SOIL/SITE EVALUATION for ON-SITE WASTEWATER SYSTEM

IMPROVEMENT PERMIT DENIAL

Re: Application for improvement Permit for property located at 10220 Truelight Church Road (Lot #1), Parcel #137-133-16

Health Department file #12387B

PROPOSED PLOT PLAN

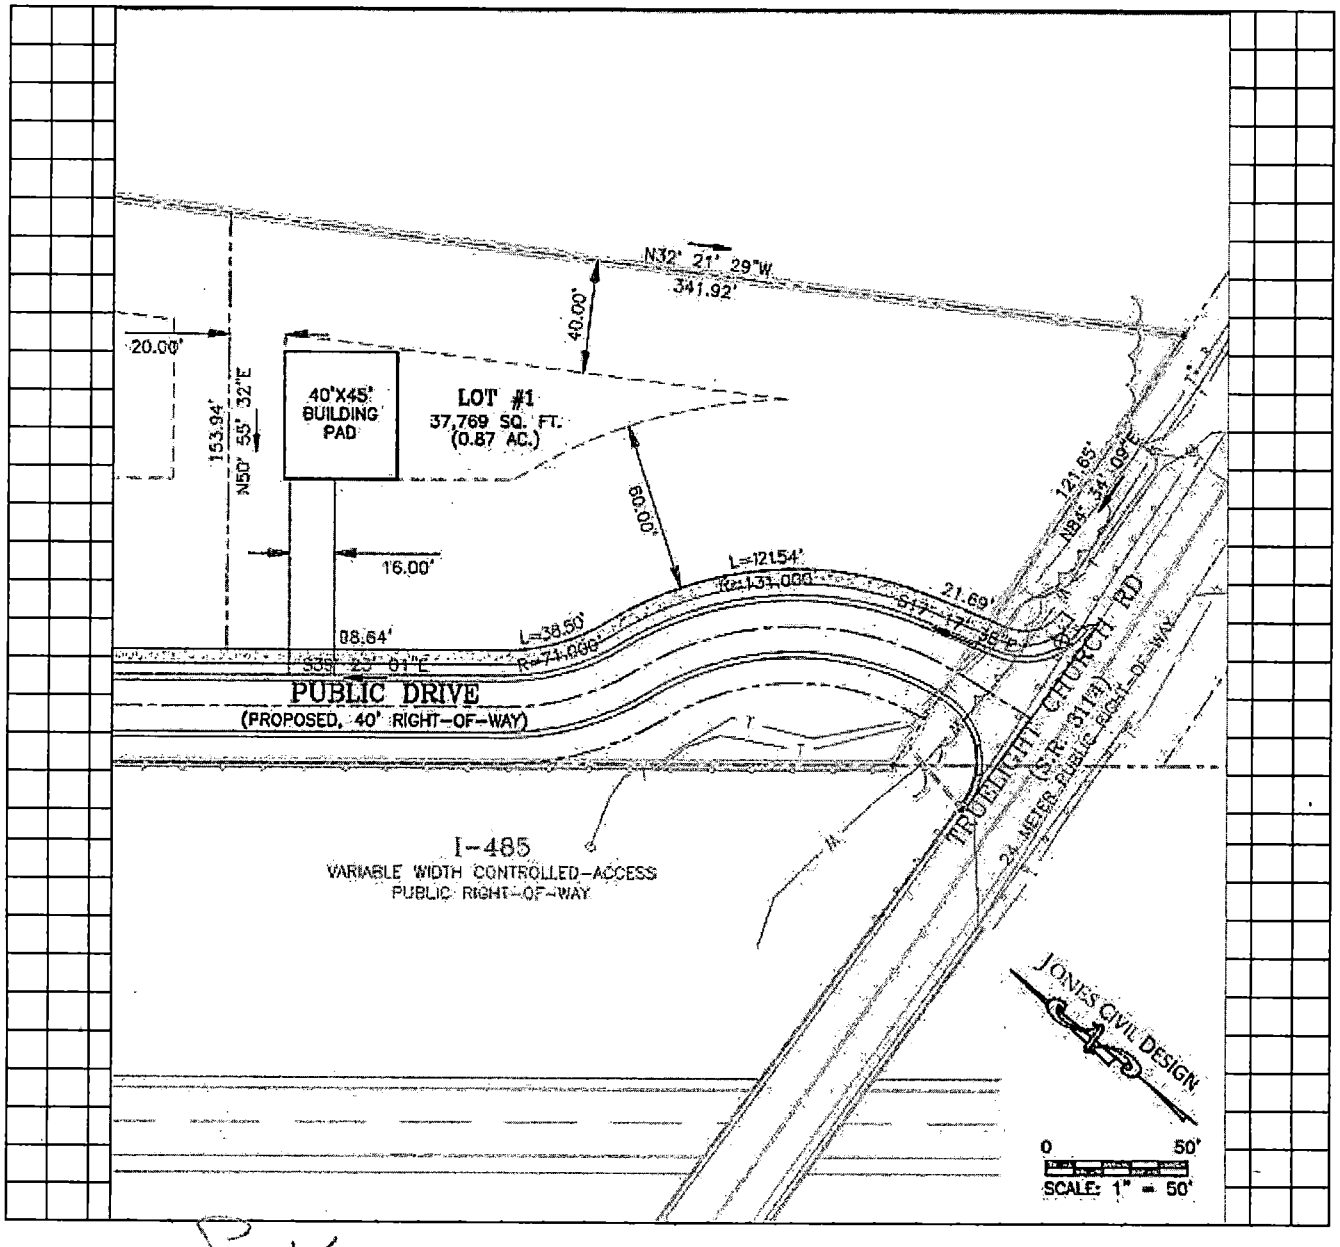
The Mecklenburg County Health Department, Environmental Health Division, on 11/17/2025 evaluated the above-referenced property at the site designated on the plat/site plan that accompanied your Improvement Permit application. According to your application the site is to serve a 5 bedroom residence with a design wastewater flow of 600 gallons per day. The evaluation was done in accordance with the laws and rules governing on-site wastewater systems in General Statutes 130A-333 to 345 and 15A NCAC 18E.

Based on the criteria set out in 15A NCAC 18E .0501 through .0602, the evaluation indicated that the site is **UNSUITABLE** for an on-site wastewater system. Therefore, we must deny your request for an Improvement Permit. A copy of the site evaluation is enclosed. The site is unsuitable based on the following:

- ☒ Unsuitable soil topography and/or landscape position (Rule .0502)
- ☐ Unsuitable soil characteristics (structure or clay mineralogy) (Rule .0503)
- ☒ Unsuitable soil wetness condition (Rule .0504)
- ☐ Unsuitable soil depth (Rule .0505)
- ☒ Unsuitable saprolite (Rule .0506)
- ☐ Presence of restrictive horizon (Rule .0507)
- ☐ Insufficient space for septic system and repair area (Rule .0508)
- ☐ Unsuitable for meeting required setbacks (Rule .0601 or .0602)
- ☐ Other (*Cite applicable rule*):_____

For the reasons set out above, the property is currently classified UNSUITABLE, and no Improvement Permit shall be issued for this site in accordance with Rule .0509(a) and (d).

Soil & Site Evaluation Map

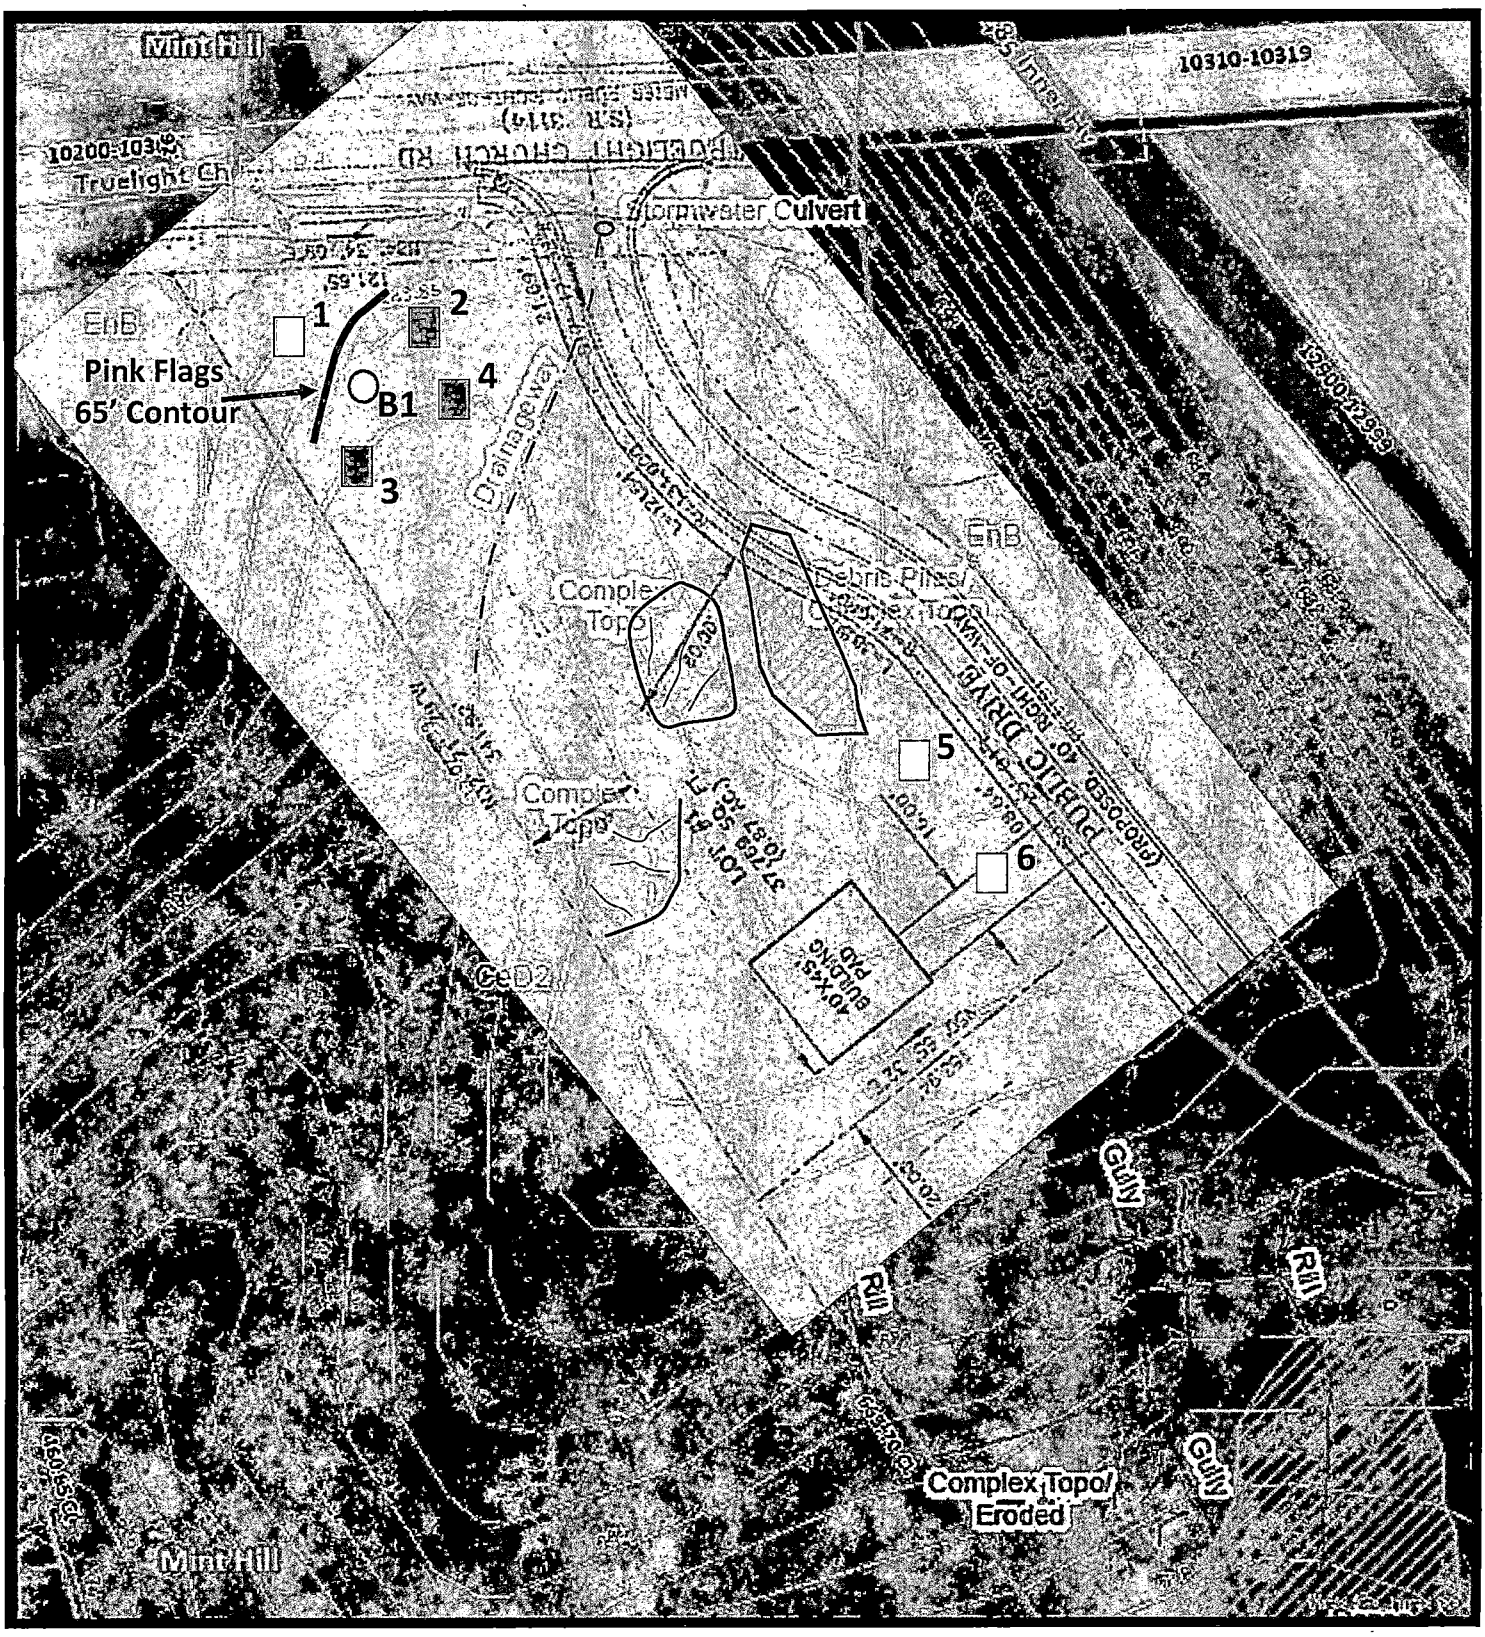
COMMENTS: 1) The area upslope of soil boring #B1 and the around soil pit #1 can be designed using an LTAR of 0.25 with a max trench depth of 32". The area of soil pits #5 & #6 use an LTAR of 0.20 with a 34" max trench depth. 2) The area of soil pits #2, #3, & #4 has a maximum trench depth of 8" for a drip system.
There is a drainageway from a road culvert running through the lot, and multiple areas of unsuitable complex topography present.
